ADDENDUM NO. 1

The following attached changes are incorporated into requirements for the Project No. 33-SBC-1001 Contract Documents by this Addendum:

KITTITAS RECLAMATION DISTRICT

SOUTH BRANCH CANAL IMPROVEMENTS

CG440
 SHEET 25 OF 35

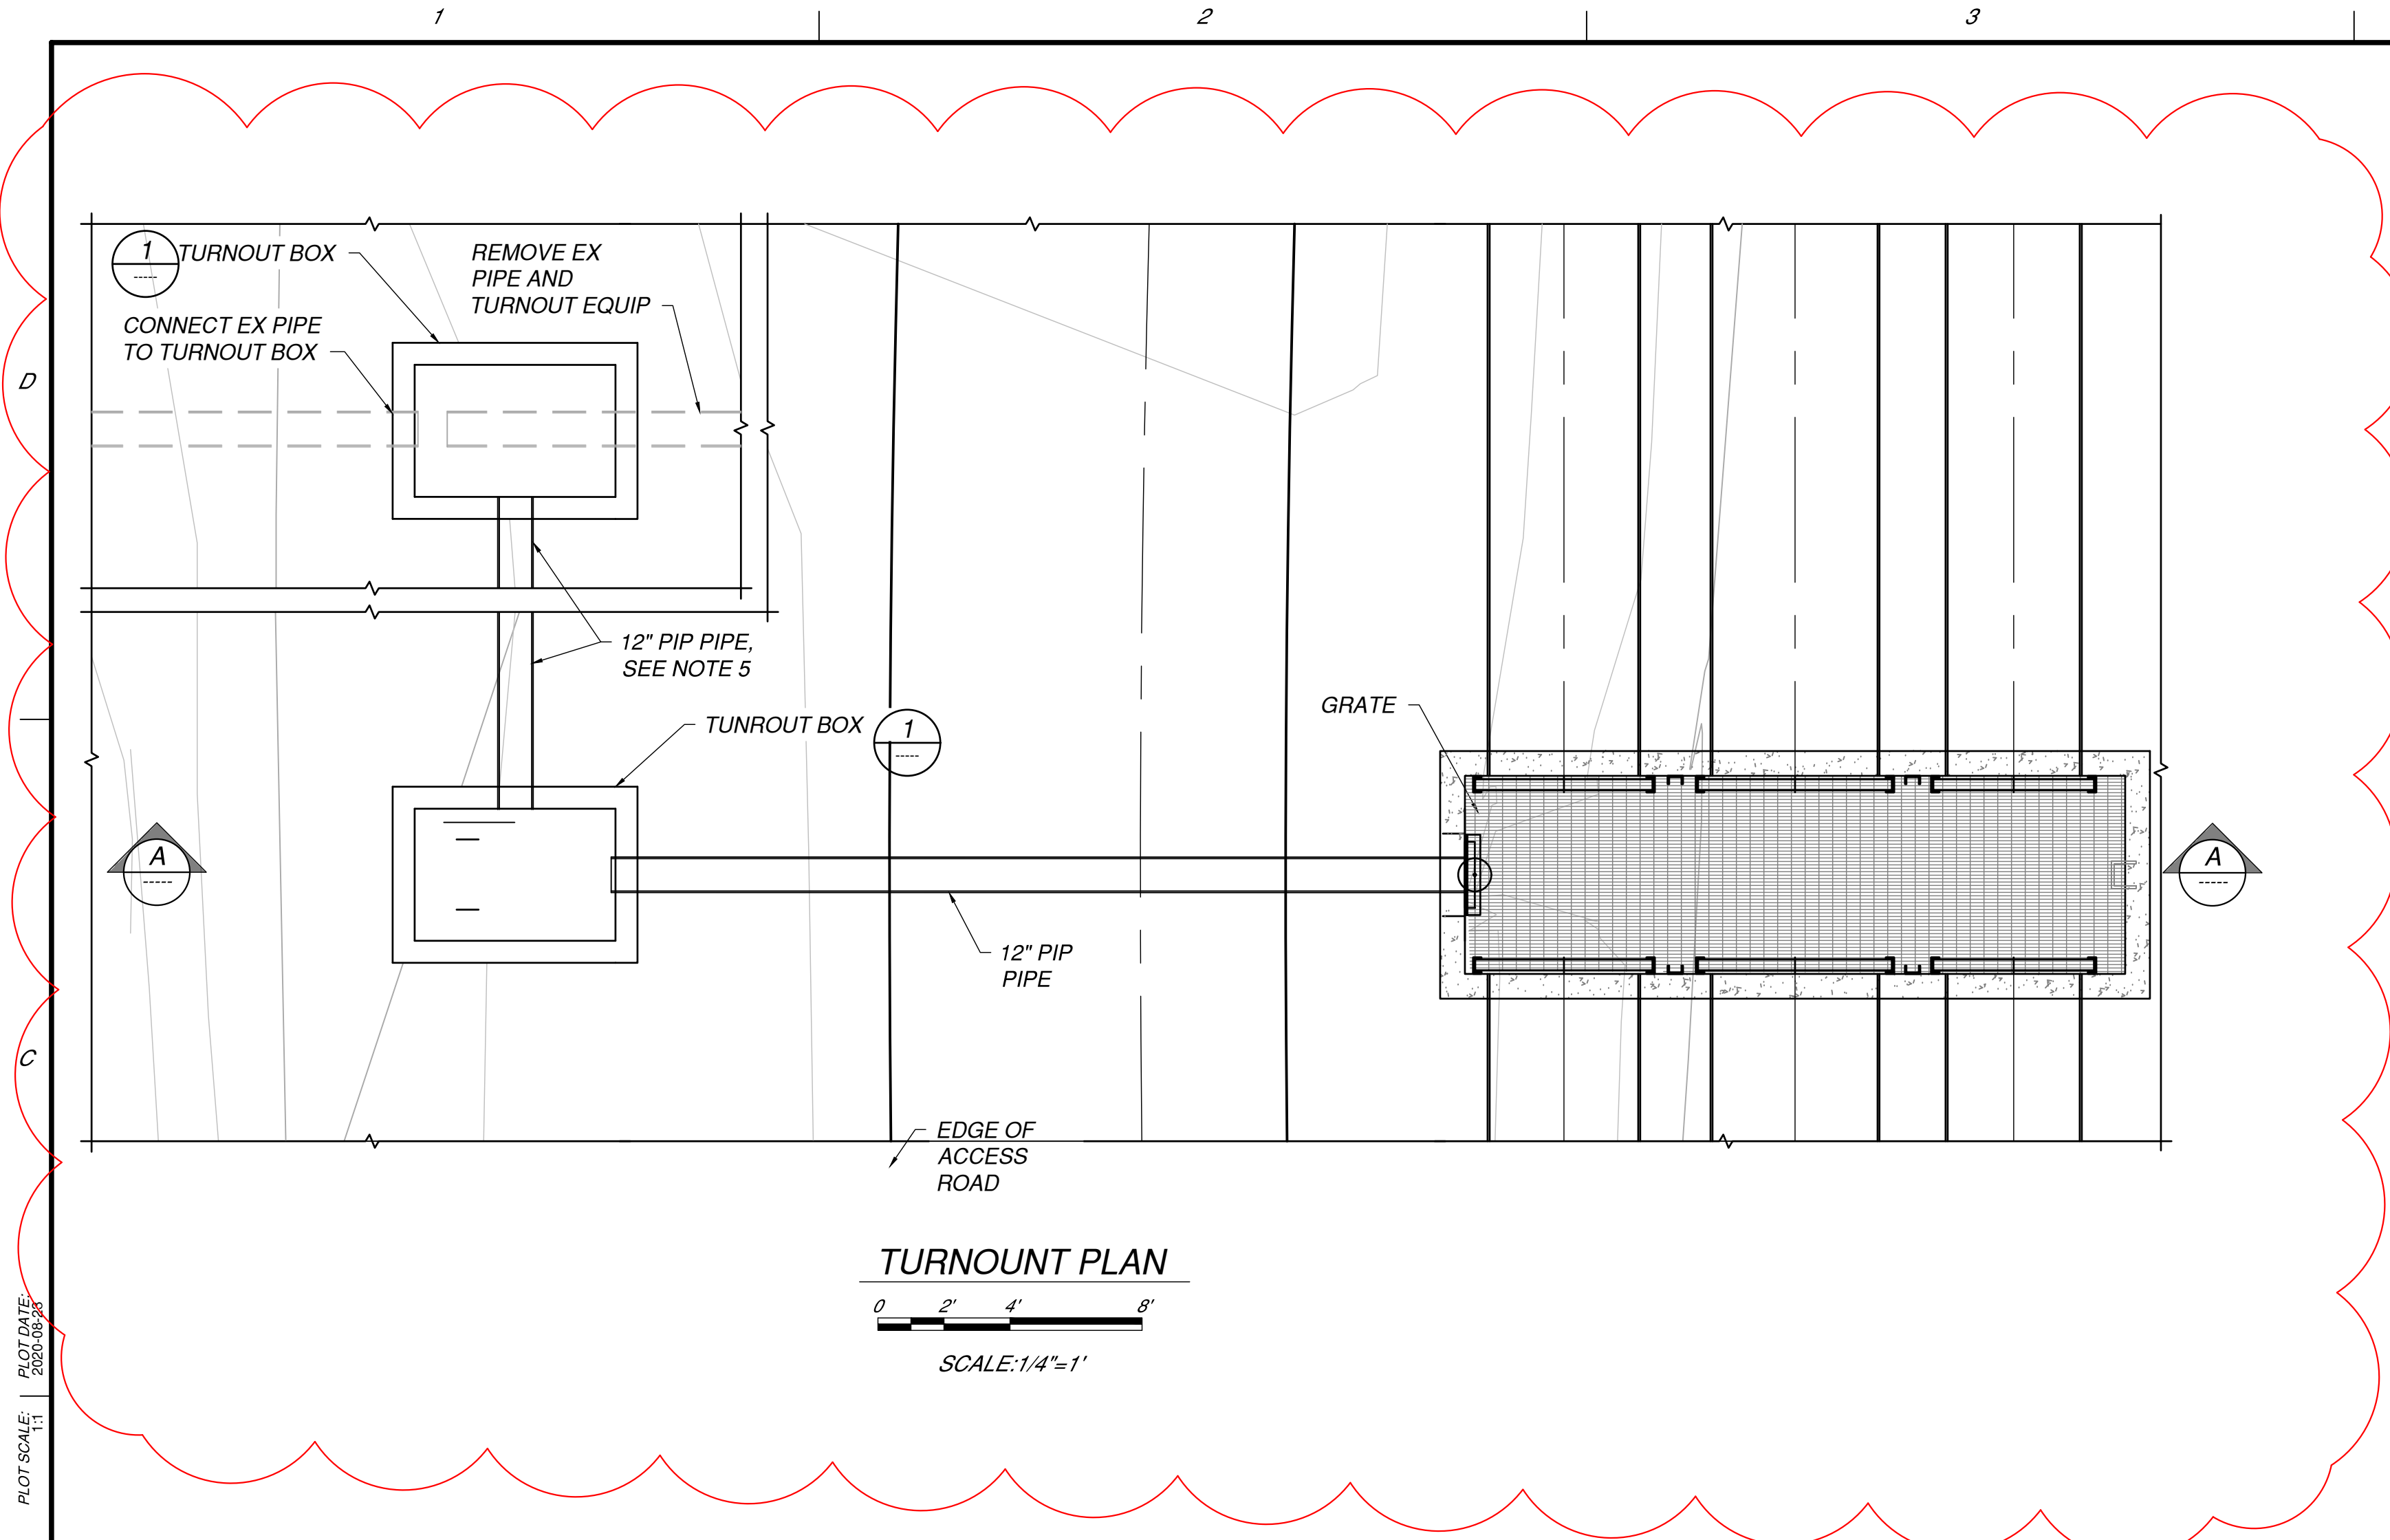
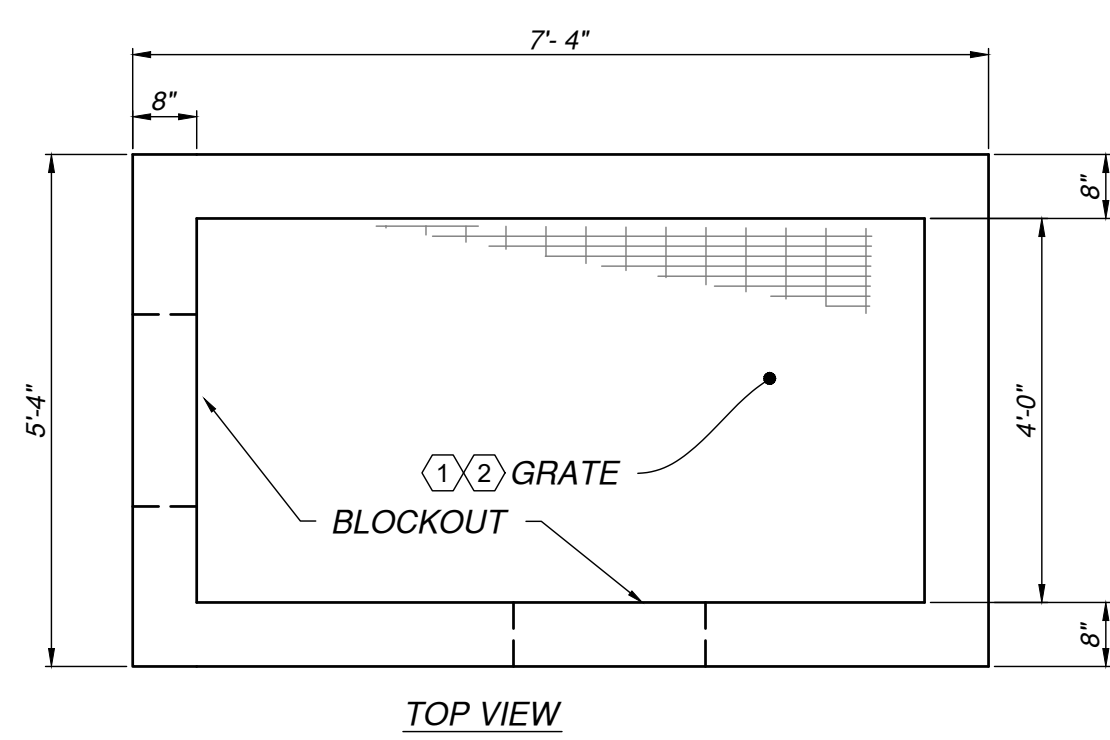
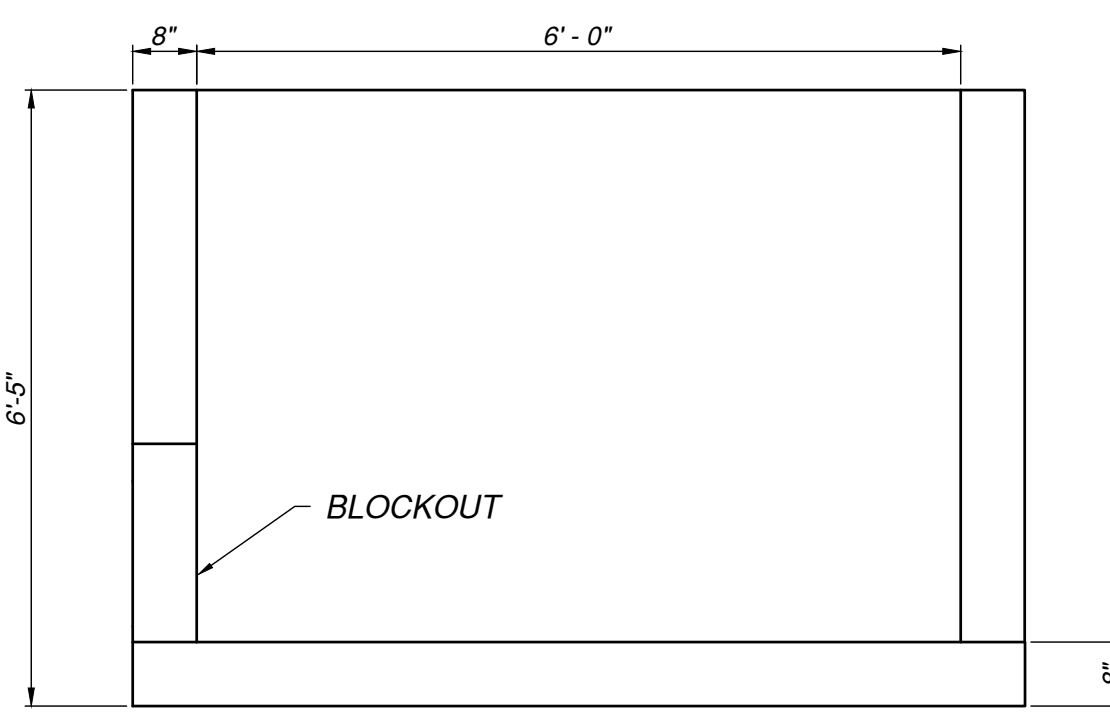
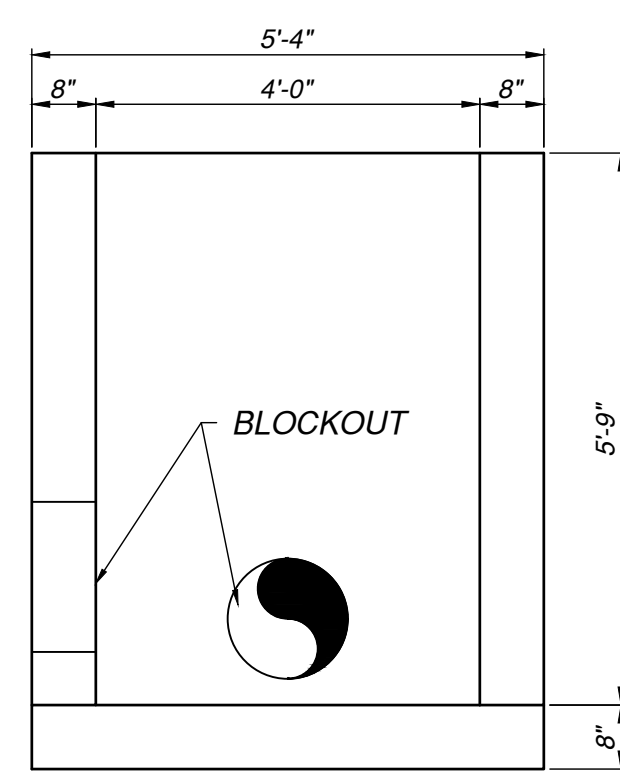
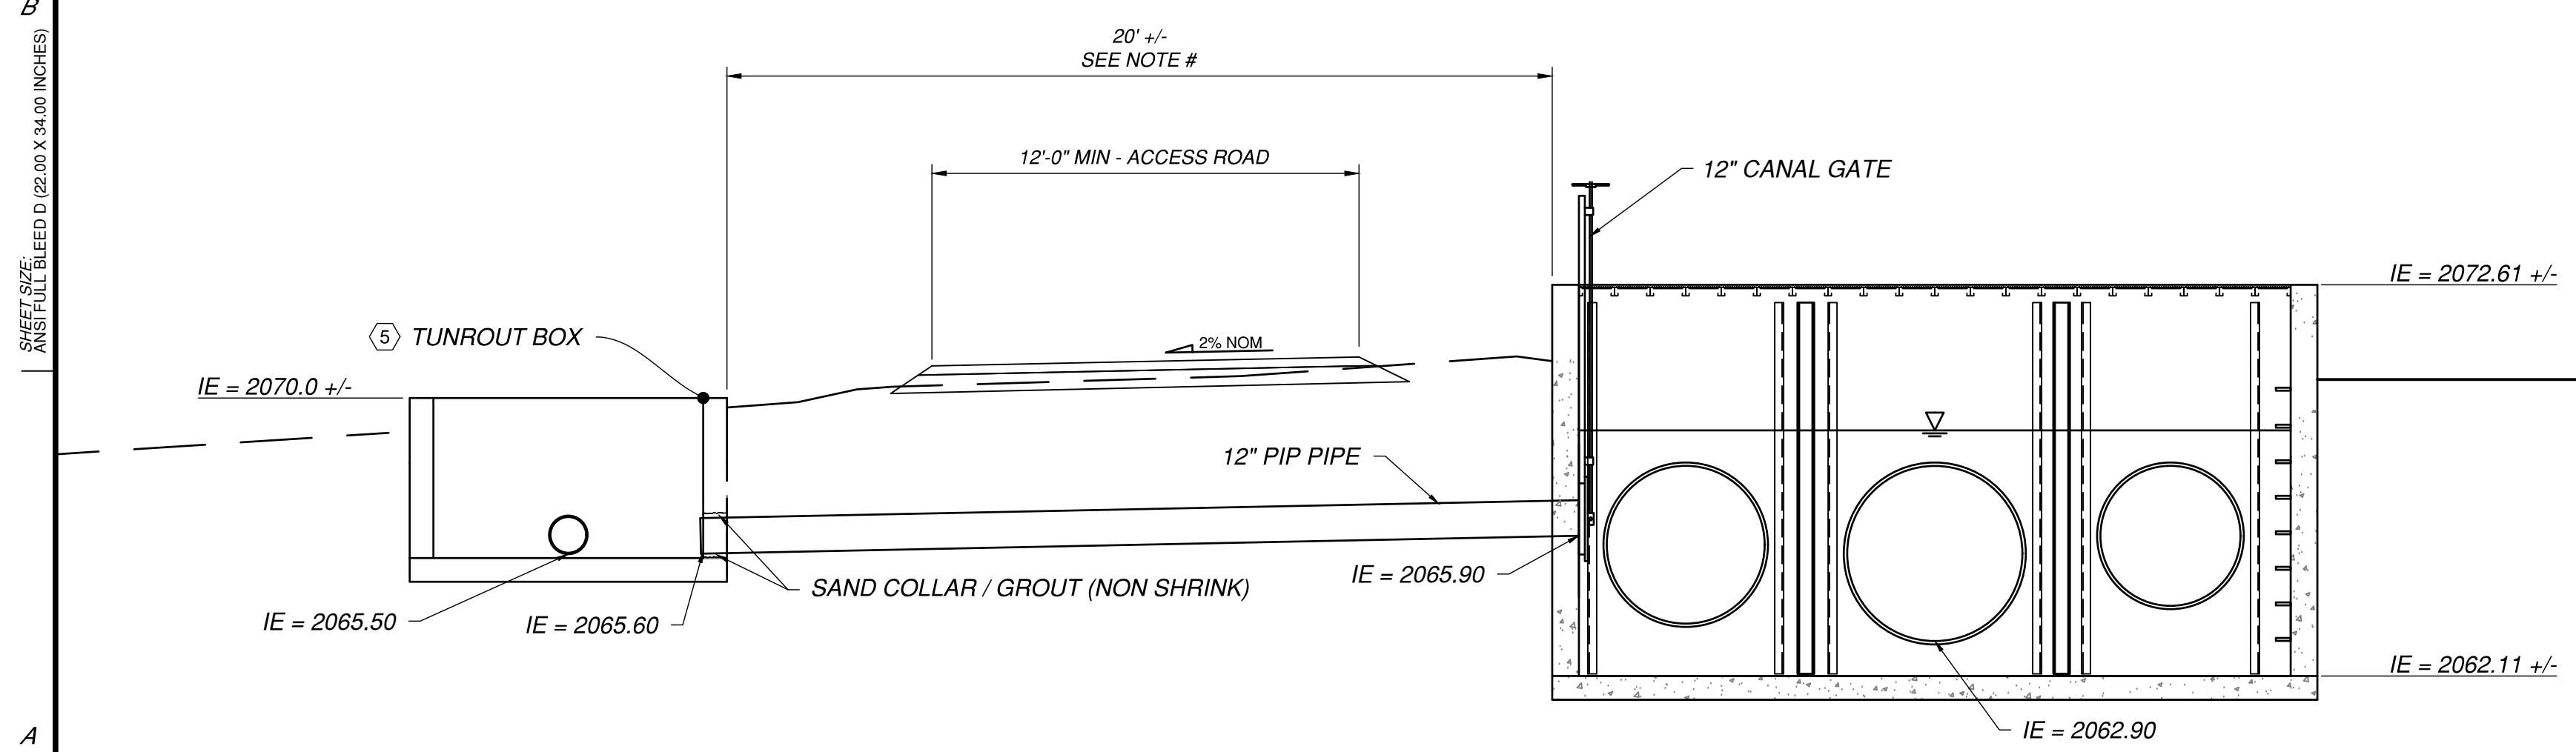
- k. Drawing CG440: Revised typical delivery box turnout partial plan.
 - l. Drawing CG501: Removed typical details unused in Robinson Siphon to Milepost 10.4.

REV NO	REV NO	REV NO	REV NO	REV NO	REV NO
				08-21-2020	08-11-2020
			1	JOHN ETULAIN	REVISOR
			0		ISSUED FOR BIDDING
					REVISED TURNOUT DETAIL
